Access Compliance Report

Public Rights-of-Way

(Curb Ramps)

Intersection ID: 3194	Main Street: HIGHCROFT_LN	Cross Street: OLD_BRIDGE_LN	Location: SE
ADA ID: 91C3C132102A	Ramp Type: Perp	Initial Pass/Fail: Fail	Overall Compliance: No
Severity Score: 12.5			
Codes/Mitigation Info/Possible Solution		Field Measurements/Component Compliance

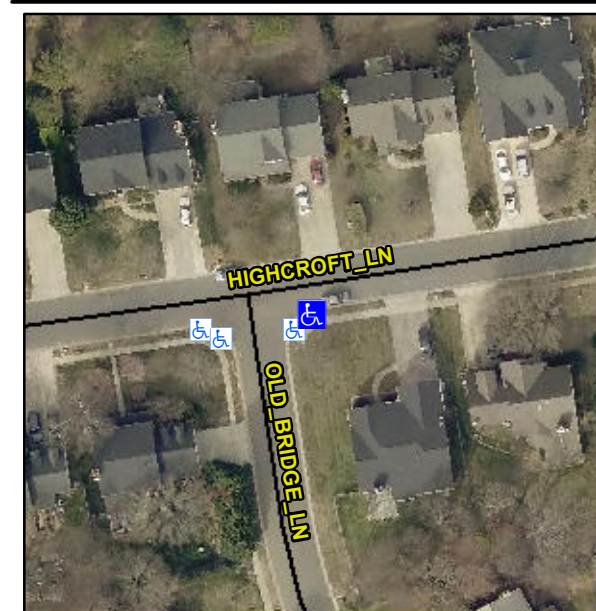
Not Found, R304.2.2

Compliance	Description	Data	Compliance	Description	Data
N/A	Ramp Length (in)	49.0	No	Ramp Slope (%)	8.6
Yes	Ramp Width (in)	49.0	Yes	Ramp XSlope (%)	0.3
N/A	Flare Type LT	N/A	N/A	Flare Type RT	N/A
N/A	Flare Slope LT (%)	N/A	N/A	Flare Slope RT (%)	N/A
N/A	Flare Traversable LT?	N/A	N/A	Flare Traversable RT?	N/A
N/A	Landing Length (in)	N/A	N/A	DWS Provided?	N/A
N/A	Landing Width (in)	N/A	N/A	DWS Contrast?	N/A
N/A	Landing Slope (%)	N/A	N/A	DWS Length (in)	N/A
N/A	Landing X Slope (%)	N/A	N/A	DWS Full Width?	N/A
N/A	Landing Curb? (Y/N)	N/A	N/A	DWS Offset (in)	N/A
N/A	Shared Landing?	N/A			
N/A	Gutter Ponding?	N/A	N/A	Gutter Slope (%)	N/A
N/A	Gutter Lip Ht (in)	N/A	N/A	Gutter X Slope (%)	N/A
N/A	Painted X Walk1?	No	N/A	Painted X Walk2?	N/A
	X Walk 1 Direction	To N		X Walk 2 Direction	N/A
N/A	X Walk 1 Width (in)	N/A	N/A	X Walk 2 Width (in)	N/A
	X Walk 1 Slope (%)	4.9		X Walk 2 Slope (%)	N/A
	X Walk 1 X Slope (%)	2.6		X Walk 2 X Slope (%)	N/A

Remove & Replace Entire Ramp.
